CORE IRRADIATION, TEMPERATURE AND FLOW LIMITS

3/4.2.2 CORE INLET ORIFICE VALVES/REGION OUTLET TEMPERATURE LIMITS

ATTACHMENT 2  
TO  
P-85481

### Justification for Deletion of Specification 3/4.1.9

FIGURE 3.2.4-3 MAXIMUM ALLOWABLE REGION TEMPERATURE RISE (°F)

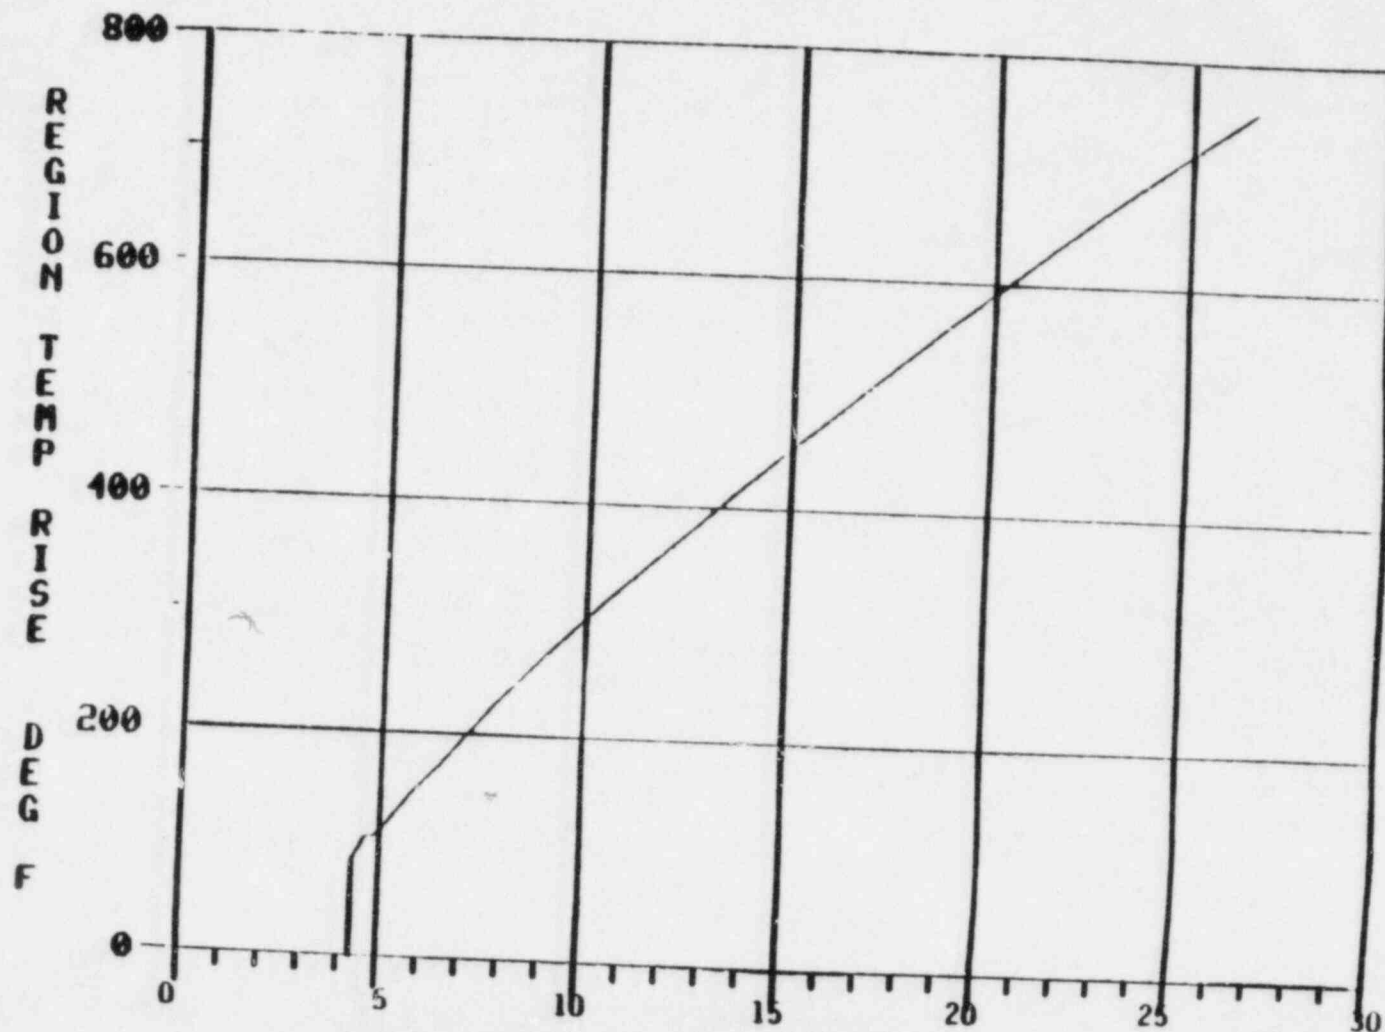
2. The CORE AVERAGE OUTLET TEMPERATURE plus the mismatch limit shown in Figure 3.2.2-1 for any remaining region.
